**MODIFICATION TO DA 4  
SECTION 75W MODIFICATION LEWIS LAGOON  
PENRITH LAKES SCHEME**

### RESPONSES TO COMMENTS RECEIVED FROM PENRITH CITY COUNCIL AND ENVIRONMENT PROTECTION AUTHORITY

**Penrith Lakes North Scheme Drainage  
Lewis Lagoon**

Figure 1: Aerial photo

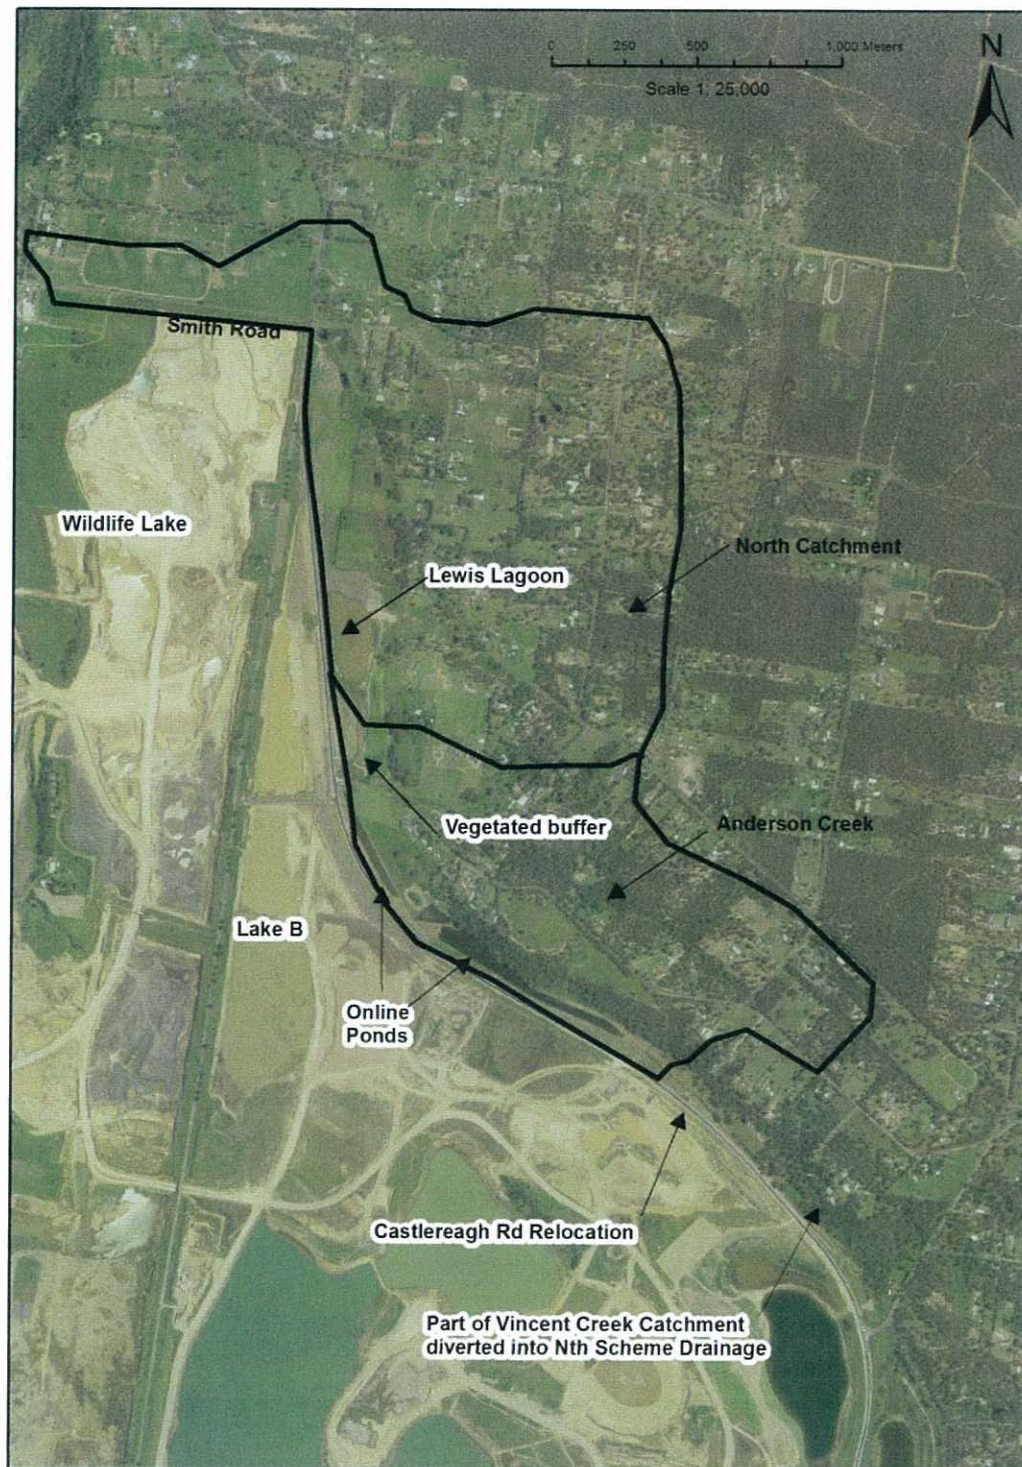
The scheme directs flows from North of Vincent Creek, Anderson Creek catchment and the North Catchment South of Smith Road to a water body identified as Lewis Lagoon, refer to Figure 1. Landuse throughout the catchment is generally rural and rural residential with sections of the Castlereagh Road Relocation also draining to the lagoon.
